ENGINE COMPONENTS, INC.

S.I. No.: 02-2

Title: CRANKCASE THRUST WASHER MODIFICATION

Revision: 1 (08/20/02)

CRANKCASE WITH THRUST WASHER MODIFICATION

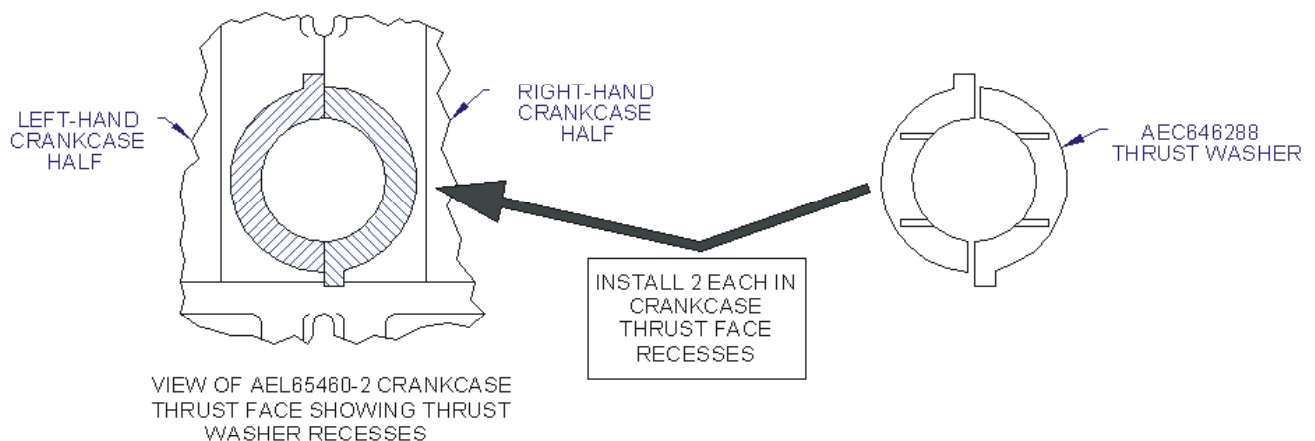
- 4.0 **PROCEDURE:** Crankcases with thrust washer modification (AEL65460-2, AEL65460-4, AEL65460-6, AEL65460-8, AEL65460-10, and AEL65460-12) must have AEC646288 (or equivalent approved replacement) installed in order to meet clearance requirements. Thrust washers shall be installed as indicated below, with the scallops/oil relief grooves facing towards the crankshaft.
